ADDENDUM NO. 1

Plans & Specifications for: Elsie Turner Field & Graverson Playground, Waltham, MA

In accordance with documents prepared by: Carolyn Cooney & Associates

DWG No. **L.102**

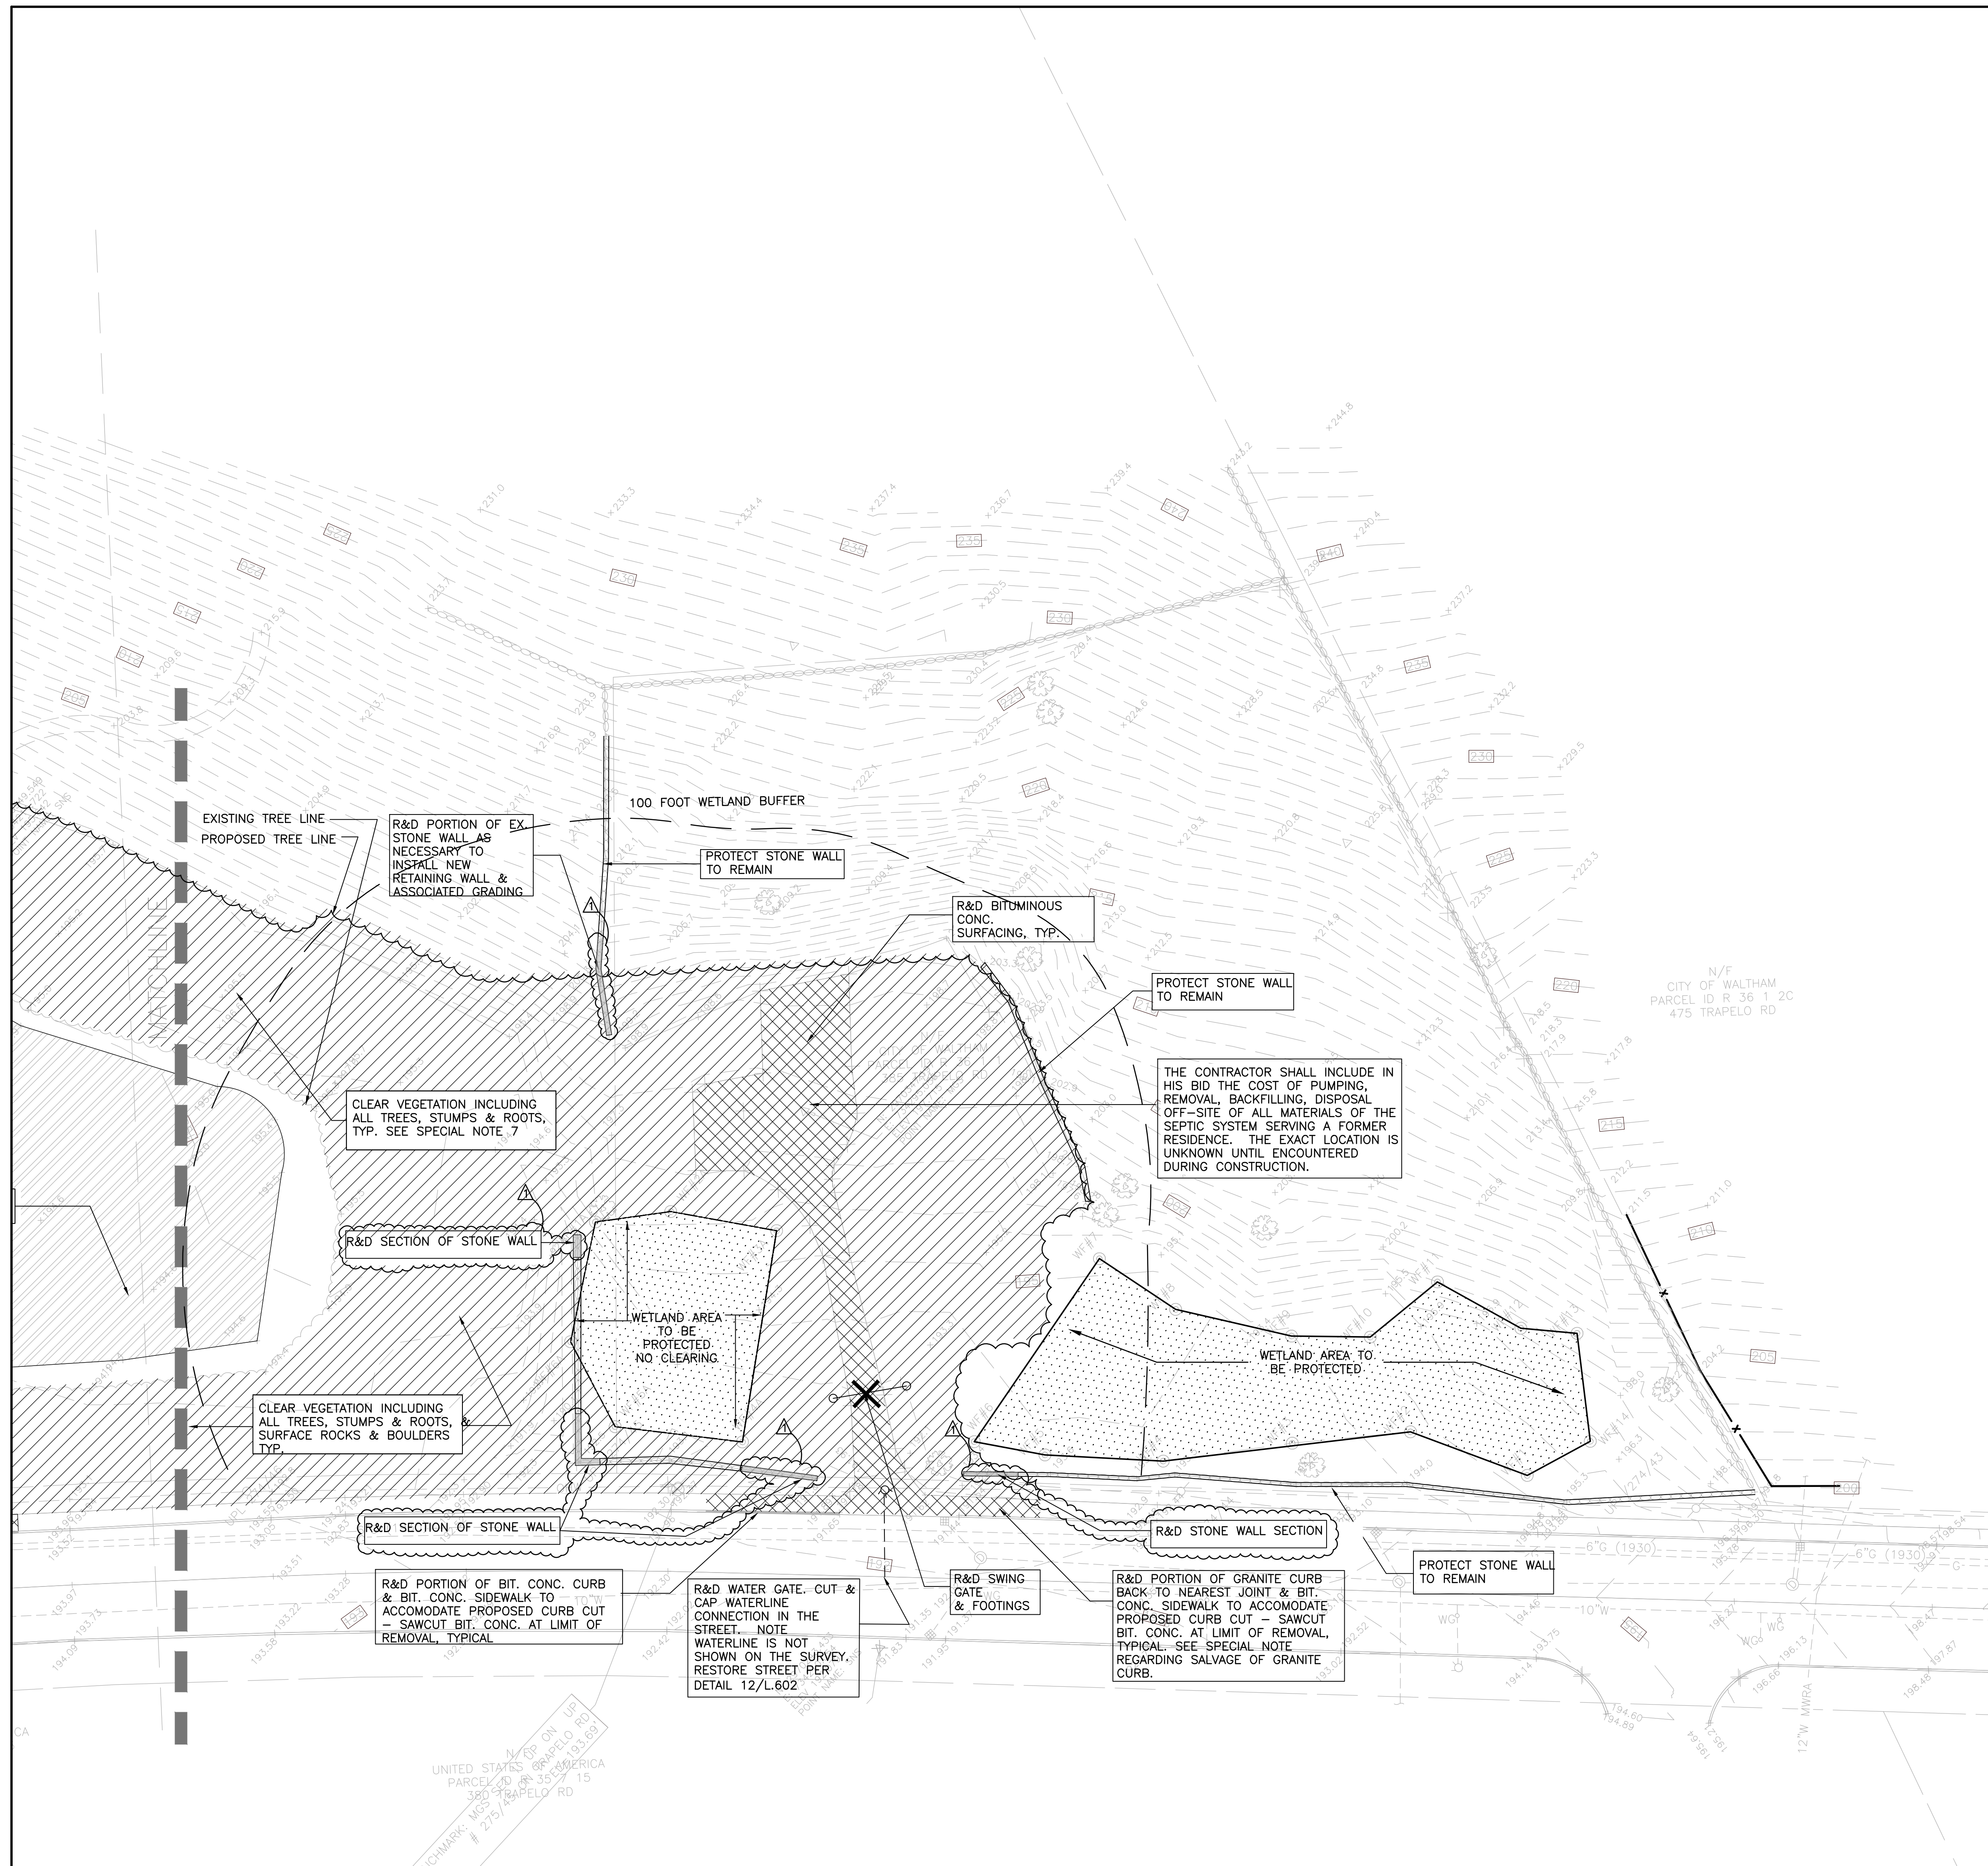
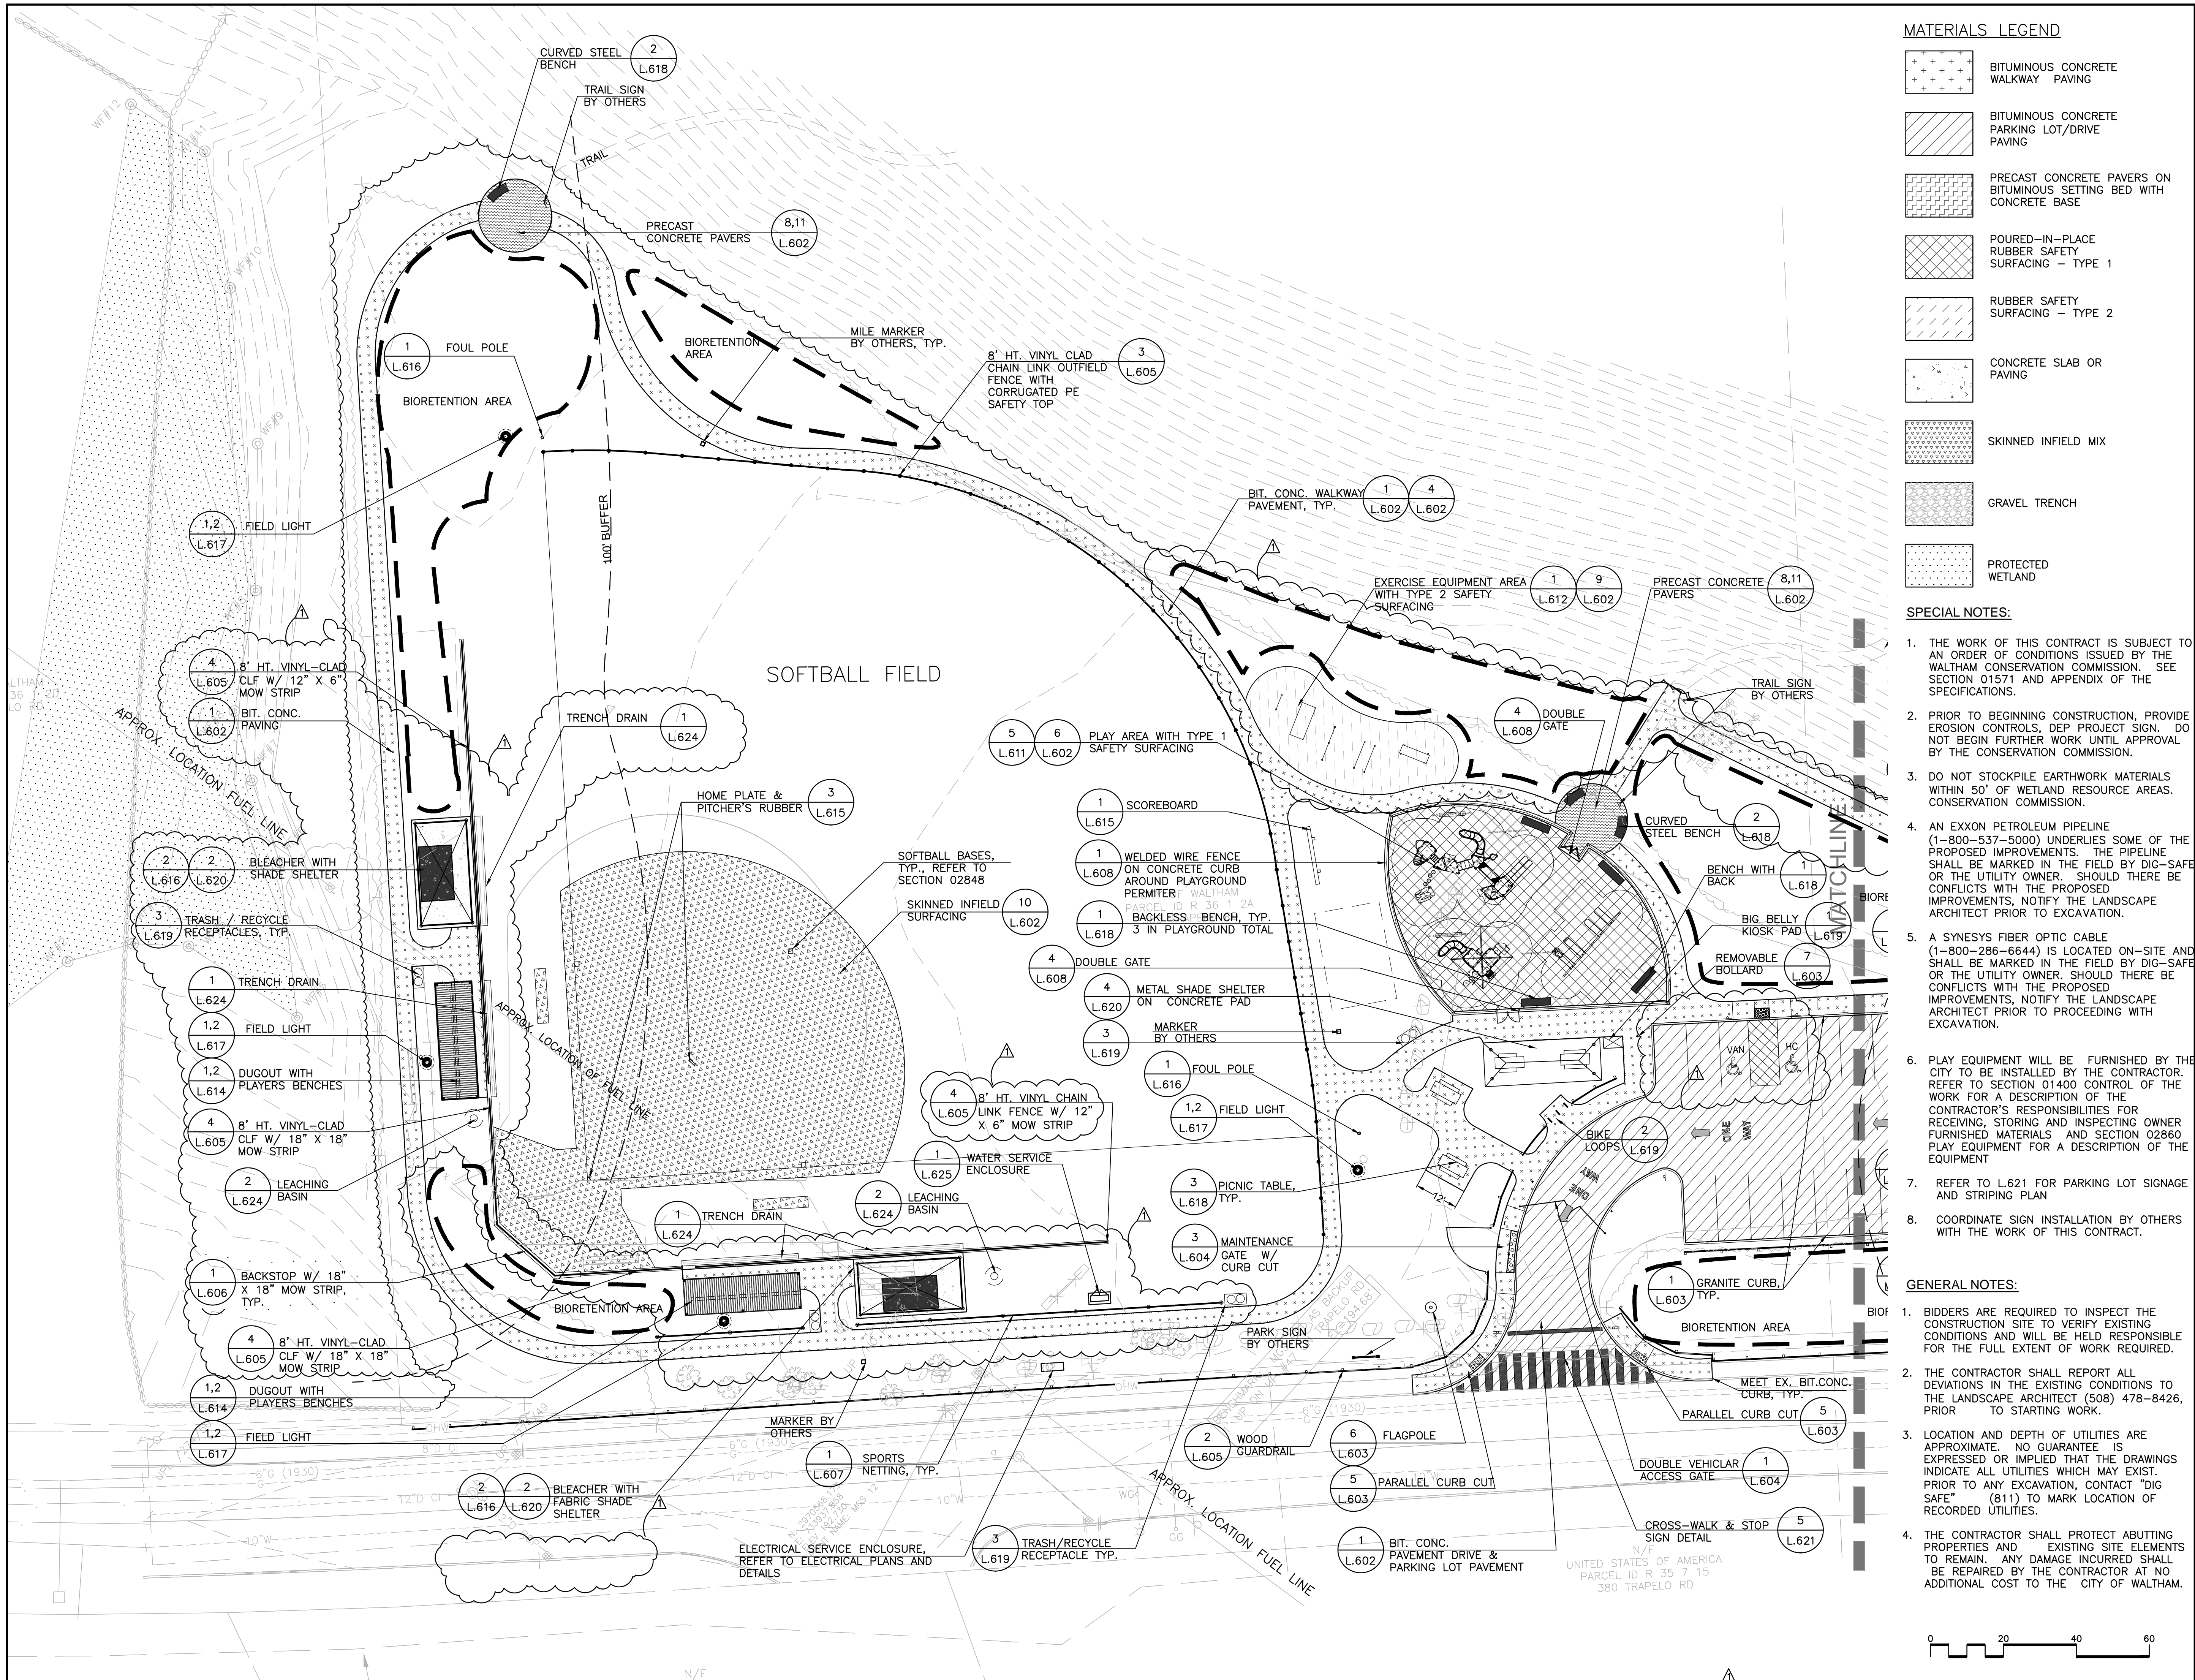
- ITEM NO. 12** *Elsie Turner Field: Replace Drawing L.101 with new Drawing L.101 attached. Revision is to clarify sawcutting requirement.*
- ITEM NO. 13** *Elsie Turner Field: Replace Drawing L.102 with new Drawing L.102 attached. Revision is to clarify portions of stone walls to remain or to be demolished.*
